# Access Compliance Report

## Public Rights-of-Way

### (Curb Ramps)

Intersection ID: 8985	Main Street: ENNIS_AV	Cross Street: GRIMES_ST	Location: SE
ADA ID: 33E89BA15F0B	Ramp Type: BlendTrans1	Initial Pass/Fail: Fail	Overall Compliance: No
Severity Score: 8.75			
Codes/Mitigation Info/Possible Solution		Field Measurements/Component Compliance

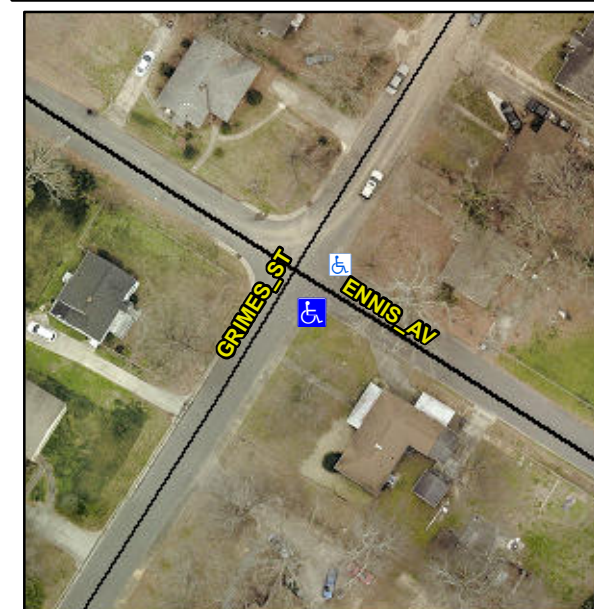
**NO CURB**

**R304.5.1**

Compliance	Description	Data	Compliance	Description	Data
N/A	Ramp Length (in)	43.5	Yes	BlendTrans Slope (%)	2.5
No	Ramp Width (in)	38.0	Yes	BlendTrans XSlope (%)	0.5
N/A	Flare Type LT	N/A	N/A	Flare Type RT	N/A
N/A	Flare Slope LT (%)	N/A	N/A	Flare Slope RT (%)	N/A
N/A	Flare Traversable LT?	N/A	N/A	Flare Traversable RT?	N/A
N/A	Landing Length (in)	N/A	N/A	DWS Provided?	N/A
N/A	Landing Width (in)	N/A	N/A	DWS Contrast?	N/A
N/A	Landing Slope (%)	N/A	N/A	DWS Length (in)	N/A
N/A	Landing X Slope (%)	N/A	N/A	DWS Full Width?	N/A
N/A	Landing Curb? (Y/N)	N/A	N/A	DWS Offset (in)	N/A
N/A	Shared Landing?	N/A			
N/A	Gutter Ponding?	N/A	N/A	Gutter Slope (%)	N/A
N/A	Gutter Lip Ht (in)	N/A	N/A	Gutter X Slope (%)	N/A
N/A	Painted X Walk1?	No	N/A	Painted X Walk2?	N/A
	X Walk 1 Direction	To NE		X Walk 2 Direction	N/A
	X Walk 1 Width (in)	N/A		X Walk 2 Width (in)	N/A
	X Walk 1 Slope (%)	3.6		X Walk 2 Slope (%)	N/A
	X Walk 1 X Slope (%)	0.9		X Walk 2 X Slope (%)	N/A

**Remove & Replace Curb Ramp With Two New Directional Ramps or Equivalent.**
